**RESOLUTION HOLDING HEARING ON REQUEST FROM TRINITY LAND HOLDINGS, LC FOR APPROVAL OF A PROPOSED 1<sup>ST</sup> AMENDMENT TO THE PAT BROKERAGE PUD CONCEPTUAL PLAN ON PROPERTY LOCATED AT 4529 DOUGLAS AVENUE**

Communication from the City Plan and Zoning Commission advising that at their January 20, 2022 meeting, the following action was taken regarding a request from Trinity Land Holdings, LC (owner), represented by Dennis Riordan (officer), for review and approval of a 1<sup>st</sup> amendment to the PAT Brokerage PUD Conceptual Plan on the property located at 4529 Douglas Avenue, to allow development of a 2.36-acre parcel along Douglas Avenue with a veterinary clinic use.

# AMENDMENT TO CONCEPTUAL PLAN FOR TRINITY LAND HOLDINGS LC A PLANNED UNIT DEVELOPMENT IN THE CITY OF DES MOINES, COUNTY OF POLK, STATE OF IOWA

# AMENDMENT TO CONCEPTUAL PLAN FOR TRINITY LAND HOLDINGS LC A PLANNED UNIT DEVELOPMENT IN THE CITY OF DES MOINES, COUNTY OF POLK, STATE OF IOWA SHEET 2 OF 4

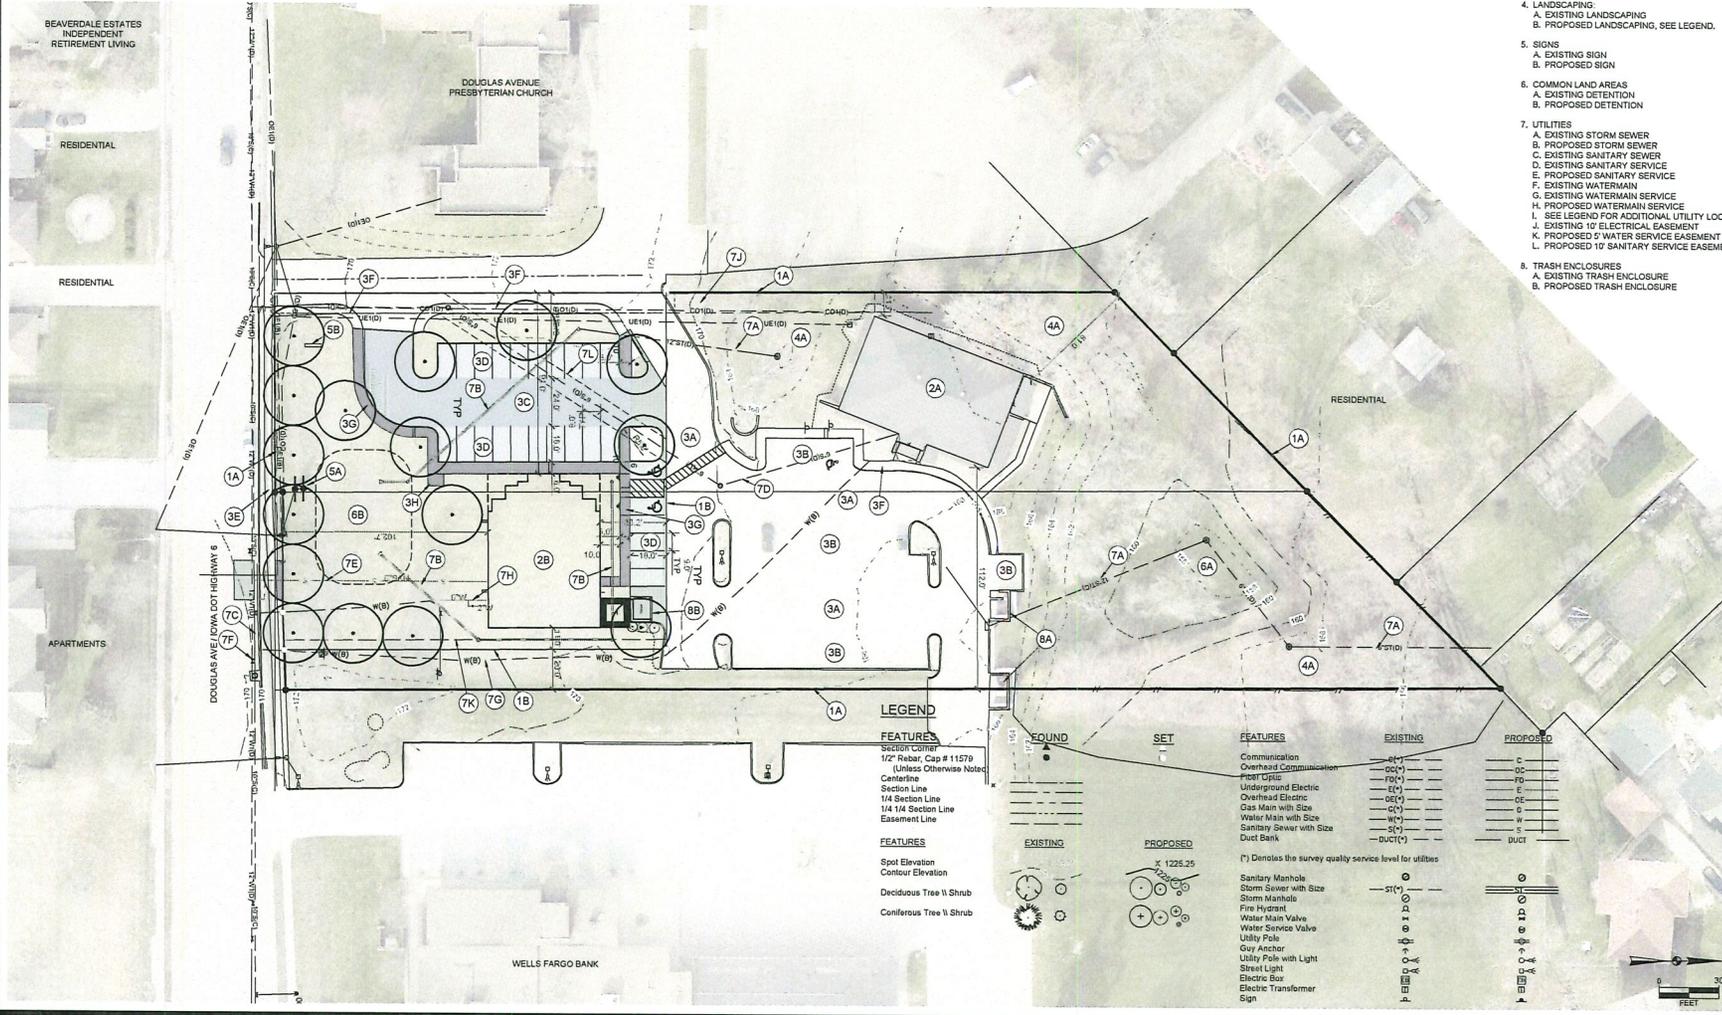
Staff believes the proposed PUD amendment is appropriate so long as the proposed structure engages Douglas Avenue by moving the building closer to the street so that it matches the setbacks of the buildings to the east and west, or is closer to the street than these two buildings. In addition, an entrance that faces Douglas Avenue should be provided.

- 6. Urban Design:** The proposed amendment includes a brick one-story structure, additional surface parking, and a stormwater system basin. The submitted site sketch indicates planting shade trees along the Douglas Avenue sidewalk (southern property line) with a stormwater basin north of the trees and open space between the basin and the proposed structure. The proposed structure would be located to the north of the open space and the adjacent existing parking spaces would be parallel to the northern façade of the proposed structure. The proposed main entrance would be located along the western façade adjacent to new additional surface parking. The proposed site sketch indicates the use of and coordination with the existing parking and drive aisle infrastructure. The proposed structure would have service entrances on the north and the east facades. The southern façade (Douglas Avenue façade) would contain two larger storefront type windows and 4 small service windows. The proposed building would include a hipped roof and building materials and design of a compatible nature to the existing building on the northern portion of the property.

Staff notes that the proposed site sketch locates the structure farther back from the primary street frontage than encouraged by the Planning and Design Ordinance. Staff understands that the proposal was designed as such to reassure neighboring property owners concerned with stormwater issues; however, City Engineering staff has determined that relocation of the stormwater system components would not be detrimental to the site or adjacent properties.

Staff believes that the proposed building should be moved closer to the street so that it matches the setbacks of the buildings to the east and west, or is closer to the street than these two buildings. In addition, an entrance that faces Douglas Avenue should be provided.

Chris Draper asked if the detention basin already exists or will it be constructed.

Abby Chungath asked how far the building needs to be from the proposed detention basin.

Chris Draper asked if there would be a concern of flooding by swapping the detention basin location.

Andrew Lorentzen asked if there were any other types of detention that would allow them to move it away from Douglas Avenue?

Johnny Alcivar asked if it would be possible to elongate the detention basin if they placed the building closer to the street.

1. The building shall setback no further from Douglas Avenue than the existing building to the east and to the west, with the finalized setback determined with the PUD Development Plan.
2. Use of full-dimensional brick or other durable material as approved by the Planning & Urban Design Administrator.

Sreyoshi Chakraborty stated the detention basin to the south of the building would be constructed with this proposal. There is an existing basin to the north.

Justin Storm, Snyder and Associates, 2727 SW Snyder Blvd, presented a current PUD outline to demonstrate their reason for the placement of the building and storm water detention basin. The detention basin will be placed on the south side to provide an overflow path to Douglas Avenue, so it won't cause issues to the north during significant rain fall. They would like the setback requirements to be deviated from the staff recommendation to allow for a 10 to 15-foot setback from the north side of the basin instead of aligning with the existing buildings to the east and west. They will add an entrance feature on the south side of the building facing Douglas Avenue.

Justin Storm stated right now some of that water goes north and some goes south. The original concept was designed for all water to flow north but given the lawsuit that occurred, they want to make sure the overflow path goes down Douglas Avenue.

Justin Storm stated no matter what you construct, the overflow will need to go overland somewhere. If we were to construct the detention on the south, it would overflow to the south, if constructed on the north, it would overflow to the north.

Justin Storm stated that could be feasible, they would need to make sure there's enough room with the building closer to the street. The building has to be at least 10 feet away from the basin to avoid issues.
